DN-190  
EN-83  
FN-70  
NN-011

# SERVICE BULLETIN

DATE: 25 JULY 1997  
PAGE 1 OF 5

## OVERRUNNING CLUTCH INSPECTION

Figure 1. Inspection of Overrunning Clutch Assembly.

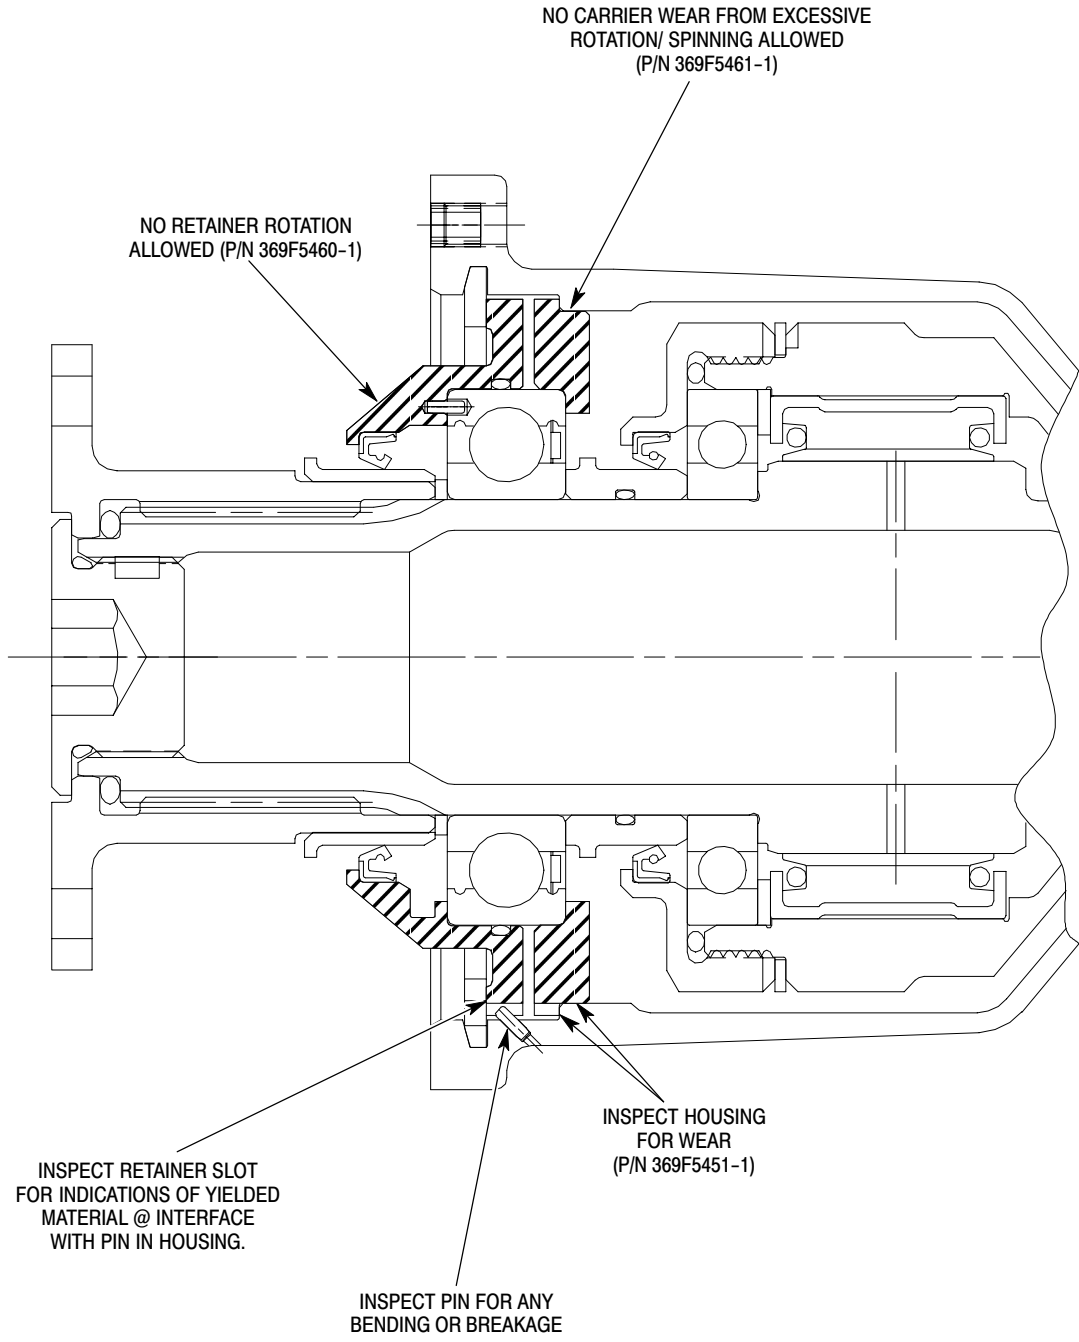
Refer to Figure 1.

- (1). Gain access to the overrunning clutch.
- (2). Remove 369F5450-1 overrunning clutch sub-assembly from housing (Ref. CSP-HMI-2, Section 63-10-00).
- (3). Inspect clutch as follows:
  - (a). Visually inspect 369F5460-1 retainer, 369F5461-1 carrier and 369F5451-1 housing at MS16556-801 pin and shoulder for indications of wear from excessive spinning.

**NOTE:** 369F5461-1 carrier slot may not be in line with the slot in the 369F5460-1 retainer. As long as no wear is observed on the carrier or 369F5451-1 housing, this relative movement is acceptable.

- (b). **Condition A:** If inspection reveals existence of either of the two following situations, the 369F5450-501 clutch assembly is to be replaced with serviceable 369F5450-501 or a new/serviceable 369A5350-605 clutch assembly (Ref. CSP-HMI-2, Section 63-10-00).

- 1). 369F5451-1 clutch housing wear and/or MS16556-801 pin damage.
- 2). 369F5461-1 carrier wear.

- (c). **Condition B:** If inspection reveals existence of only the following situation, with no damage to the 369F5451-1 clutch housing and MS16556-801 pin, the currently installed 369F5450-1 clutch sub-assembly is to be replaced with a serviceable 369F5450-1 clutch sub-assembly.

- 1). Yielded material in the 369F5460-1 retainer outside diameter slotted area which interfaces with the MS16556-801 pin in the 369F5451-1 housing

**NOTE:** Installation of a new/serviceable 369A5350-605 or serviceable 369F5450-501 clutch assembly requires removal of the engine.

- (d). Record aircraft serial number, clutch serial number, run time on clutch and date of inspection.
- (4). If no wear, indication of spinning or pin damage is observed, reinstall 369F5450-1 overrunning clutch sub-assembly into 369F5451-1 housing.
- (5). Upon reaching 100 hours of additional operation time, return to step 2.(1). and proceed accordingly.
